Village on Blain

PLANS AND DOCUMENTS
referred to in the ULDA
APPROVAL dated 3 / 7 / 12

AMENDED IN RED
- 6 JUN 2012

Drawn By: <u>Geoff Walker Urban Design</u>	Checked By: <u>The BAV Trust</u>
Project: <u>Blackwater Residential Subdivision</u>

Plan of Development 6942-A101

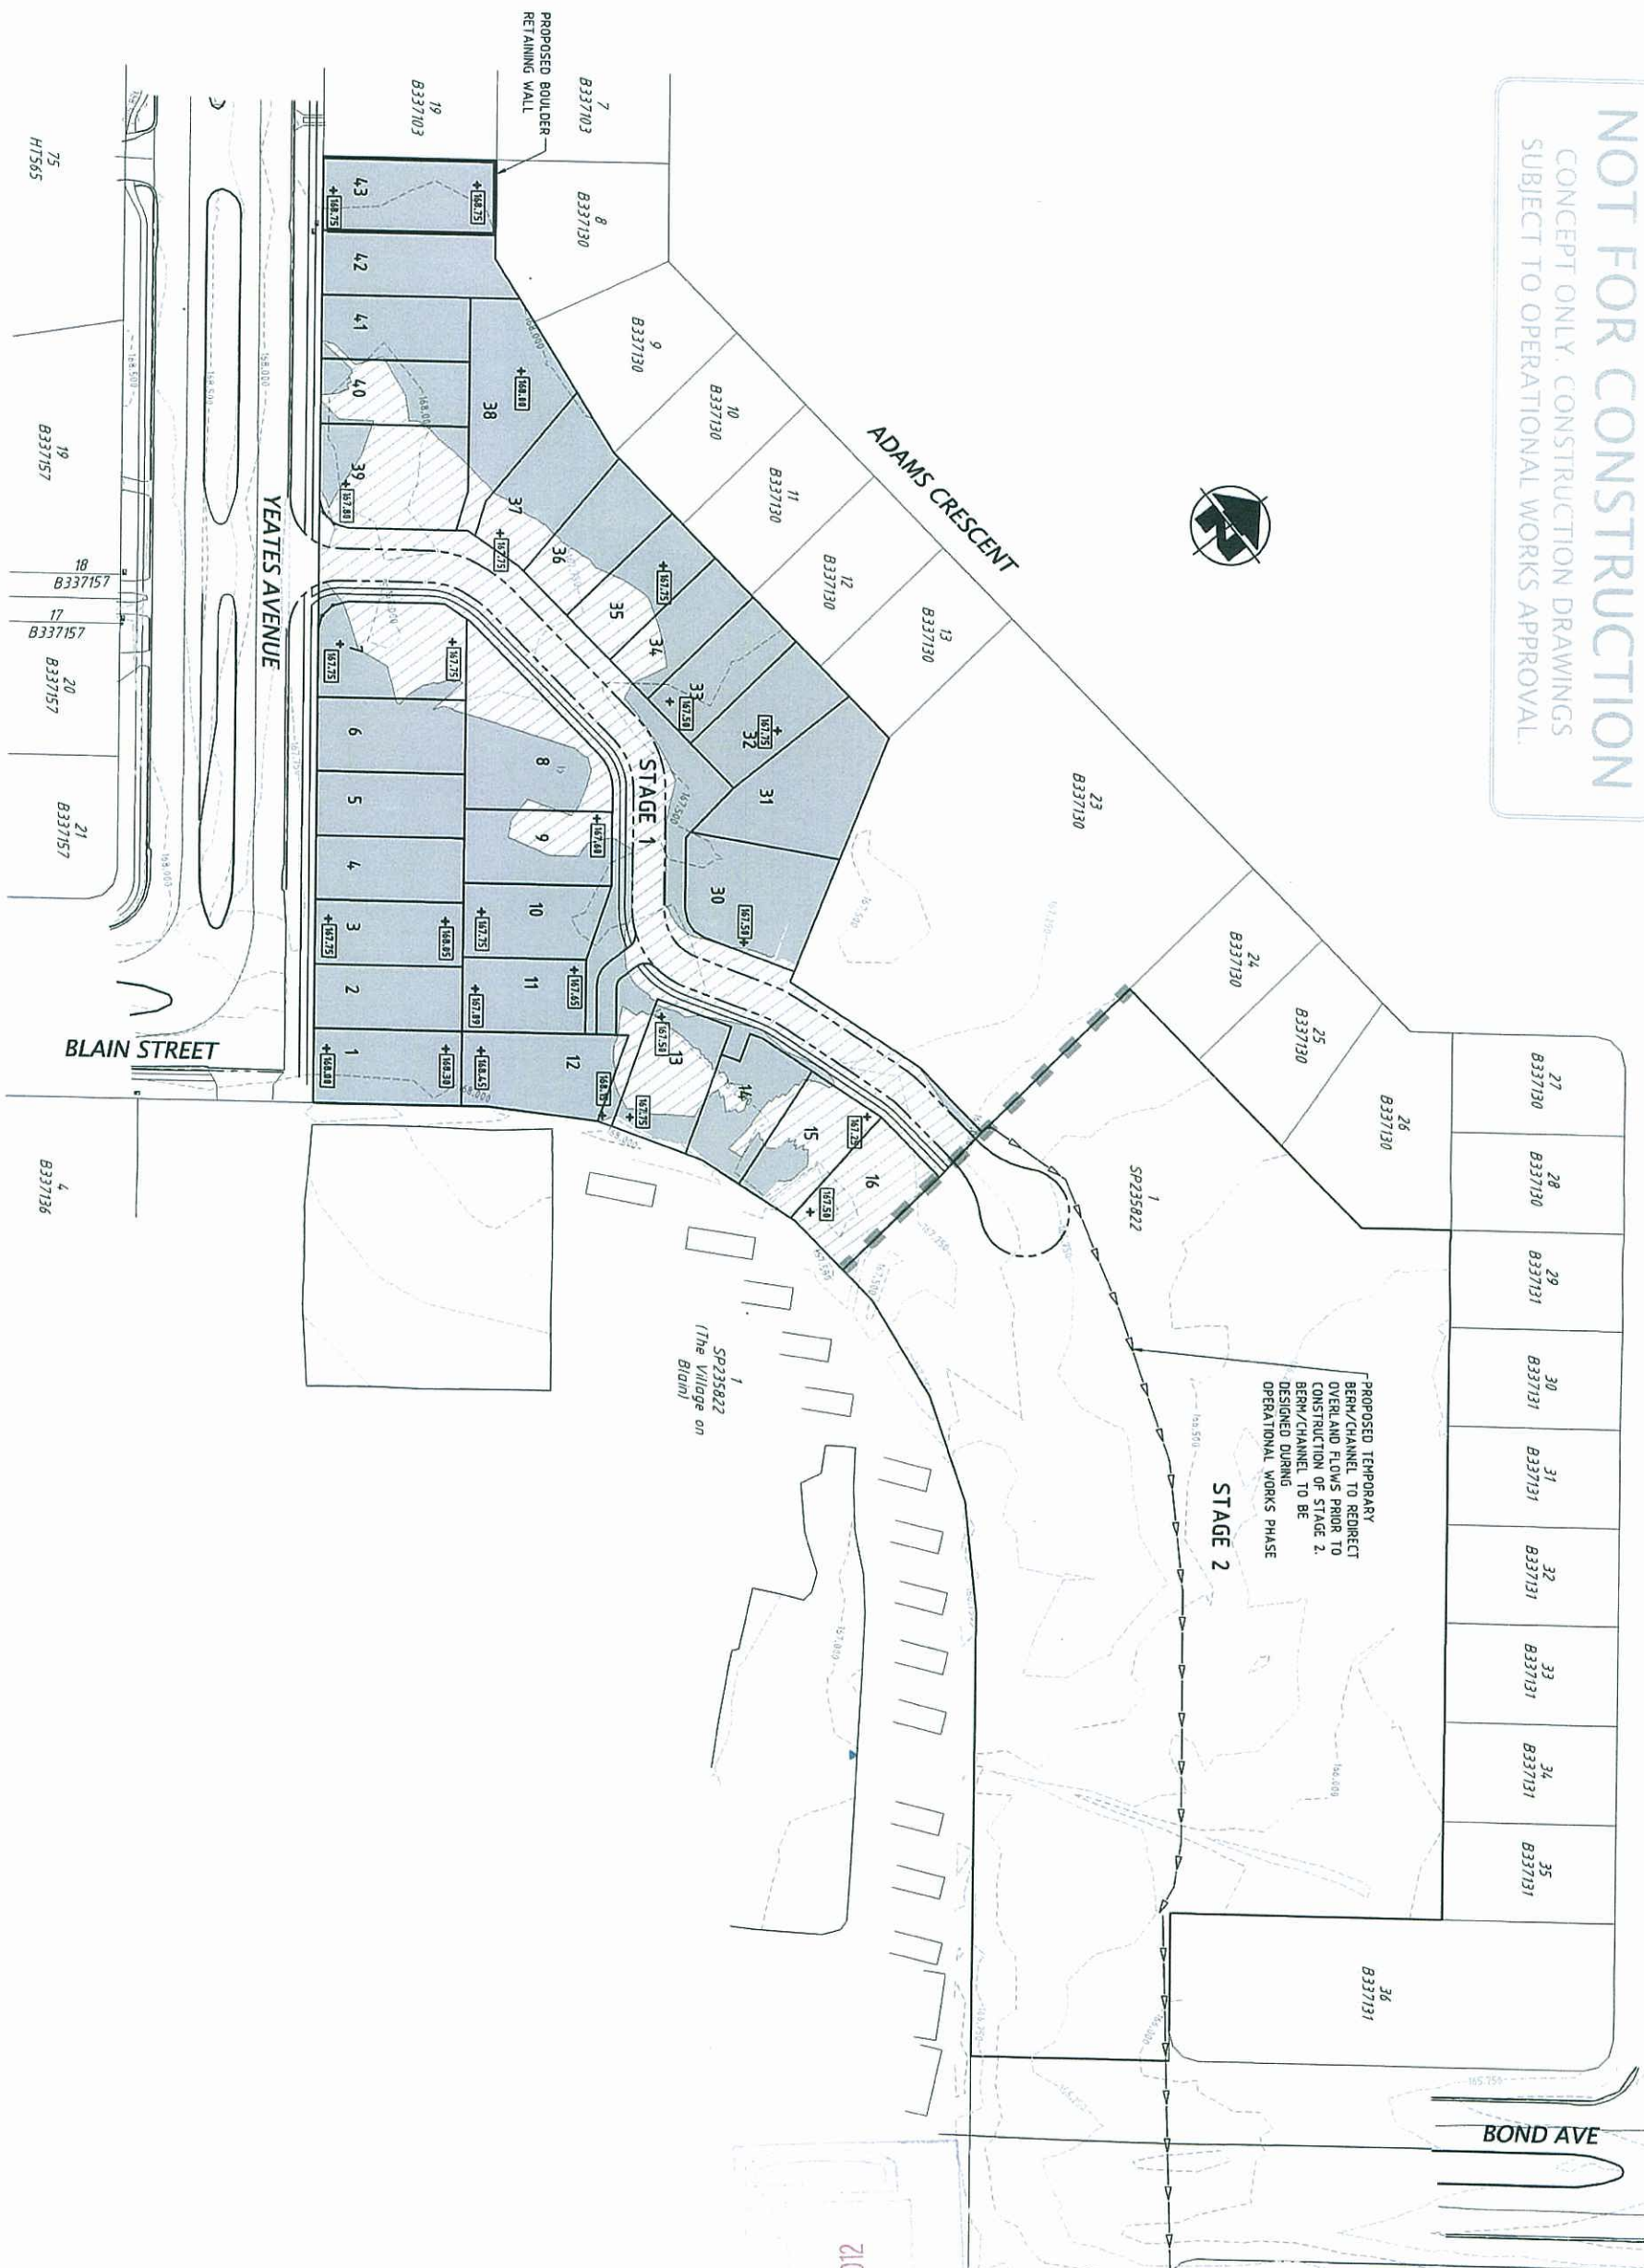
AMENDED IN RED

21 AUG 2013

By: OWEN HASZM (name)
